MODIFICATION SHEET FOR RCE-101F & W

How RCE-101F & W is wired to operate Chrysler Grand Cherokee to May 2001.

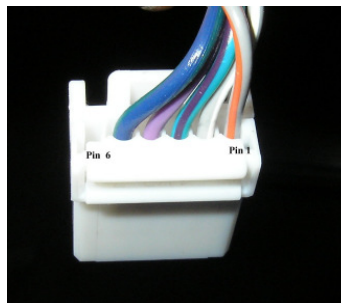
How to modify RCE-101F & W to operate Chrysler Grand Cherokee from May 2001 to 2006.

- a.) Connect BLUE wire to YELLOW wire Pin 1.
- b.) Connect BLACK wire to GREY wire Pin 2.
